IFB No. **17-08 East & Jefferson High School Dust Collections**

RE: **ADDENDUM NO. 1**

PROJECT NUMBER: BFA # 984A / 984B SD205 # 1705 / 1706
FOR: Dust Collection System
East High School
ADDRESS: 2929 Charles Street, Rockford, IL
Jefferson High School
4145 Samuelson Road, Rockford, IL

CONSTRUCTION LAB DUST COLLECTION SYSTEM

ME1

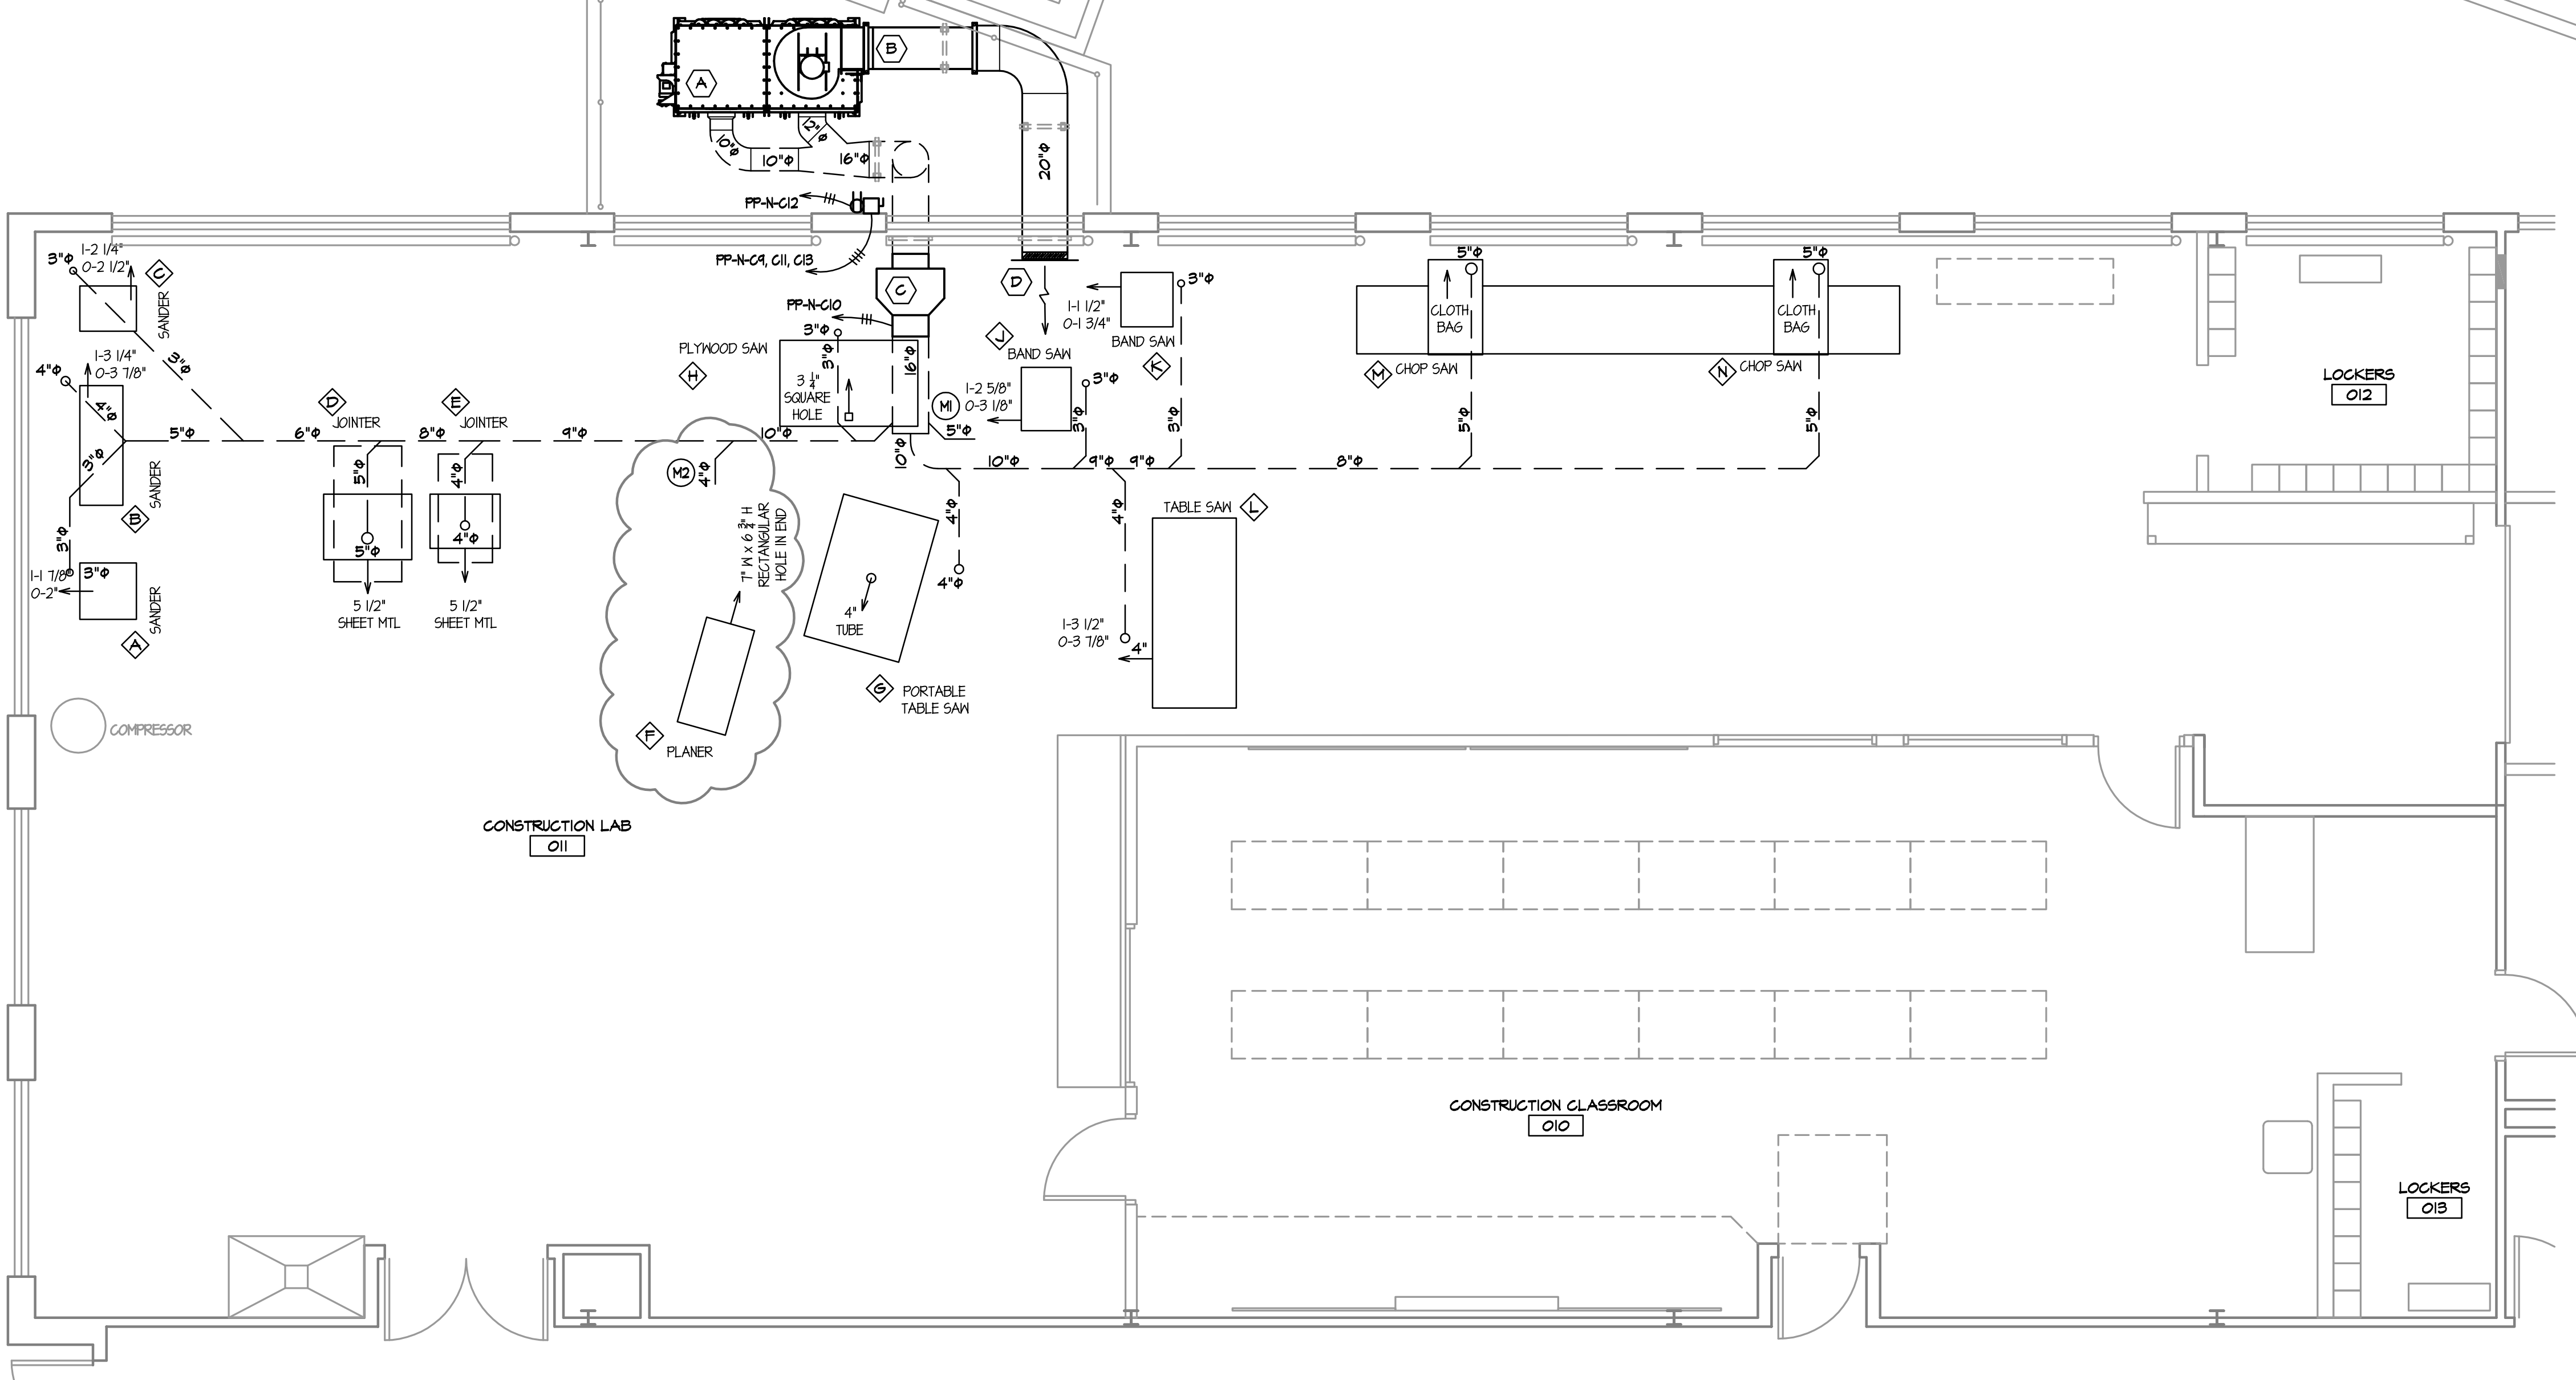
2) QUESTION: Clarify the location of the explosion valve. Dirty or clean side.

Changes to sheet ME1

Omit the drop to the planer. Omit the modifications to the planer to accommodate collection. Provide 4" bleed to accommodate future connection. Correct Elevation 1.

ANSWER: The plan drawing is correct. Ductwork Elevation 1, Sheet ME1 incorrectly indicates the location of the explosion valve. Revised Sheet ME1.
